Cockle Bay Park Redevelopment State Significant Development Application (SSD DA) Stage 2

MOD-1 Envelope Modifications Proposal

Prepared for DPT Operator Pty Ltd and DPPT Operator Pty Ltd
01.11.2021

Compliance Clarification: Public Pergolas/Shading

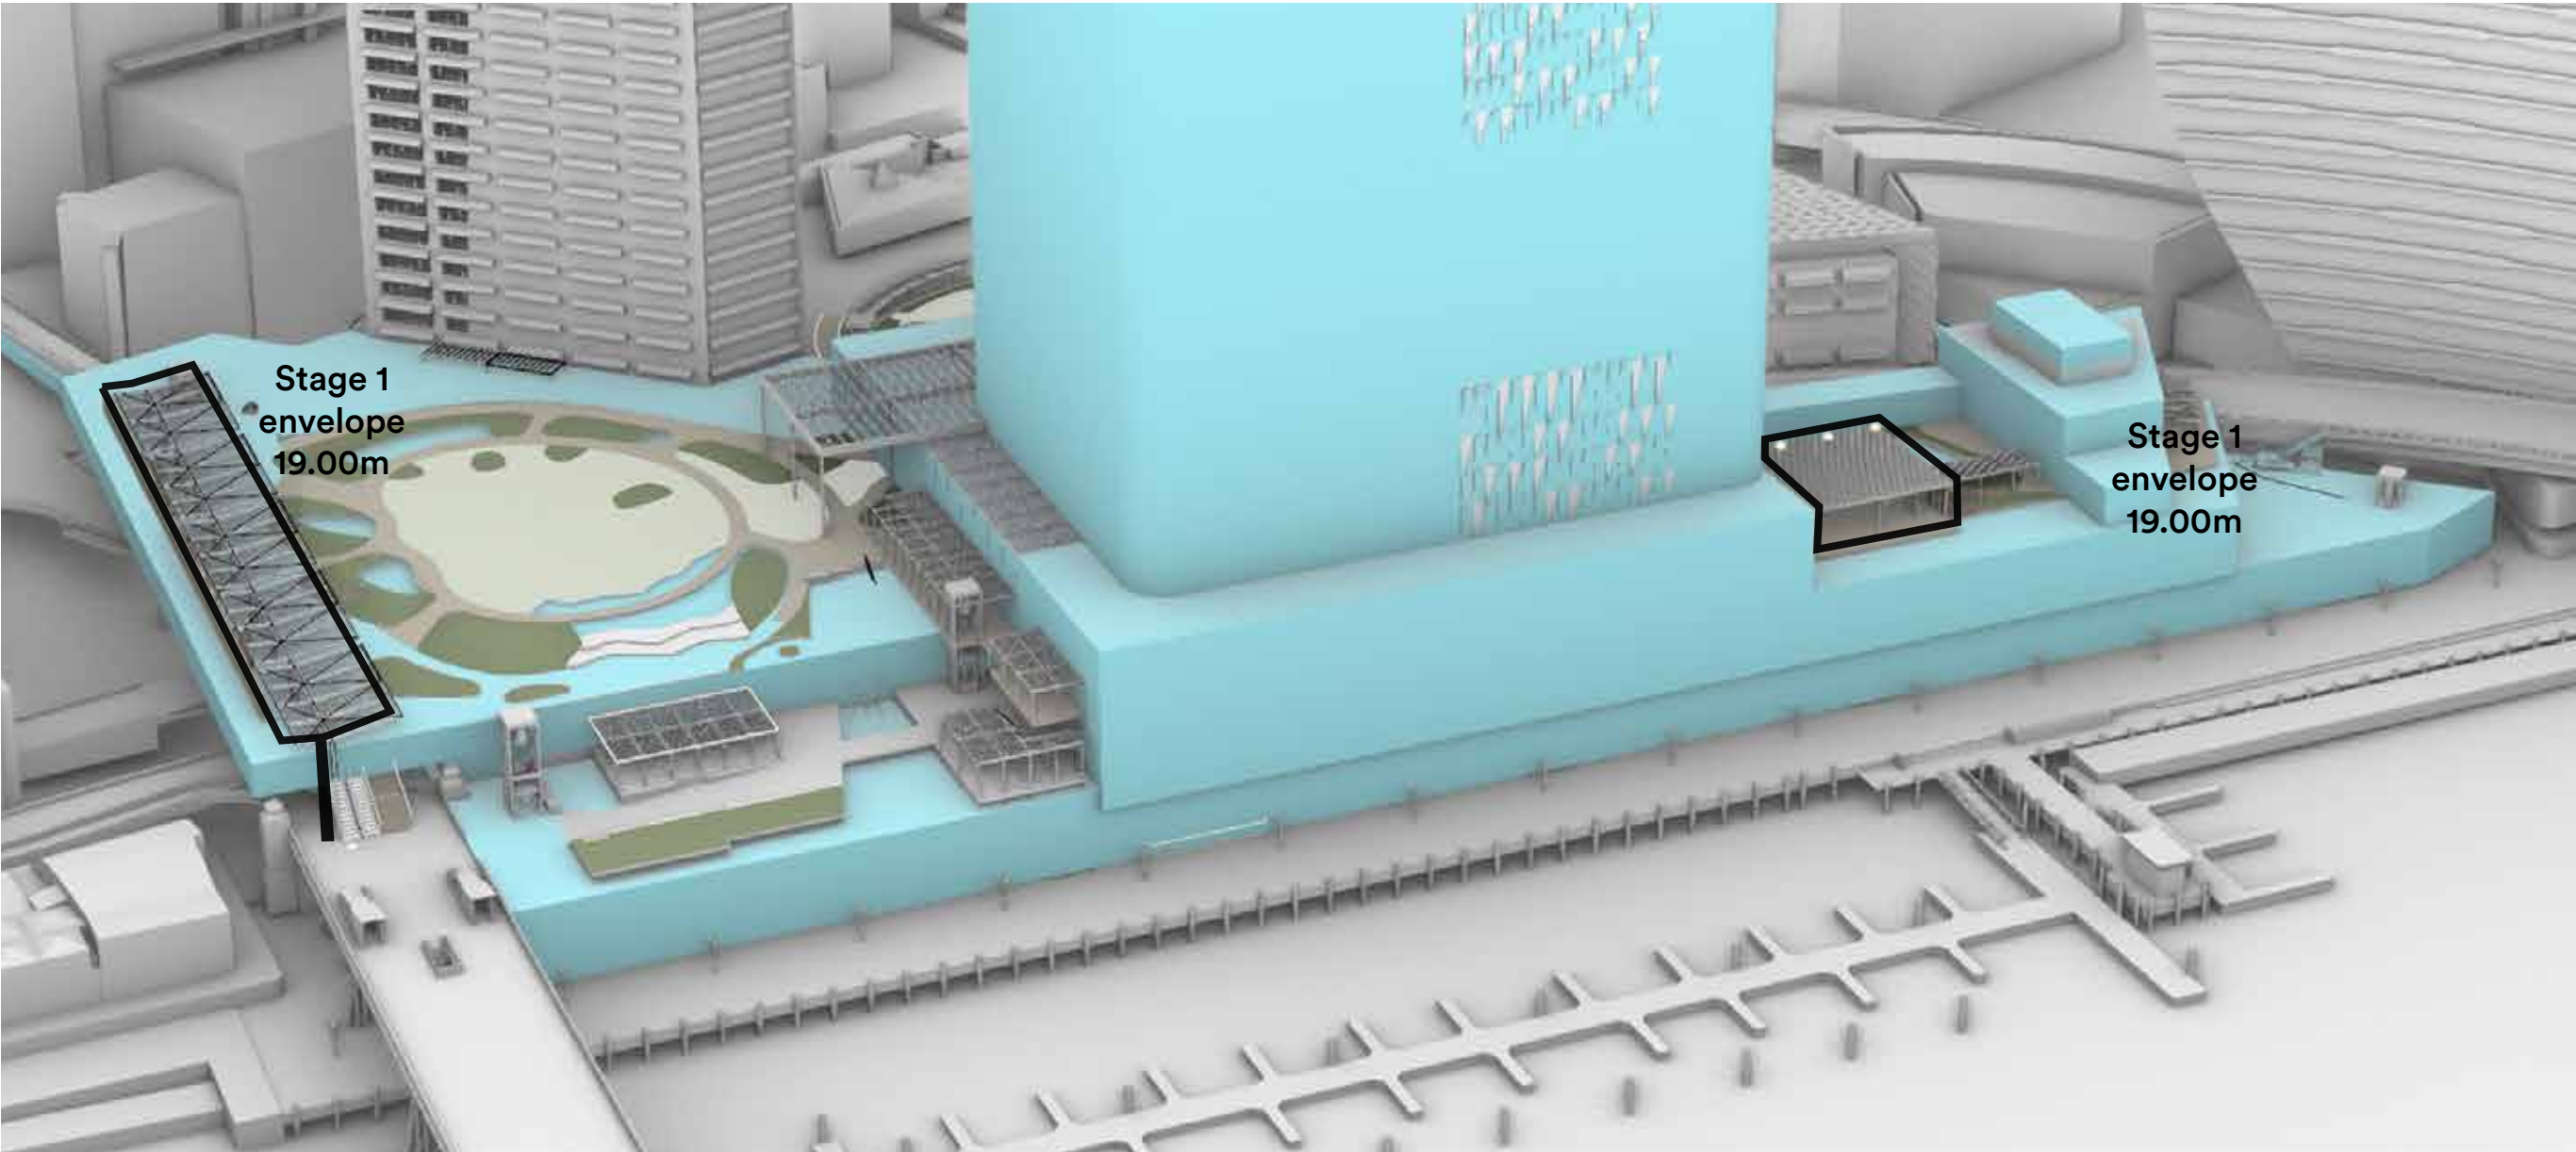
The Concept (Stage 1) DA permits garden pavilions and kiosks beyond the building envelope where these components are within, and relate specifically to, the publicly accessible open space or the public domain. The proposed pergolas are associated with the Northern and Southern park spaces and, therefore, are aligned with publicly accessible open space and public domain areas. In the case of the pergolas within the public domain, these refinements, therefore, would fall within the permitted exemptions and are appropriate and supportable.

Others pergolas around the base of the Tower provide much needed solar shading and climate comfort to external areas. They also shelter vertical transport elements, such as escalators, from the rain. The pergolas close to the Tower help to reduce down draught from winds around the Tower.
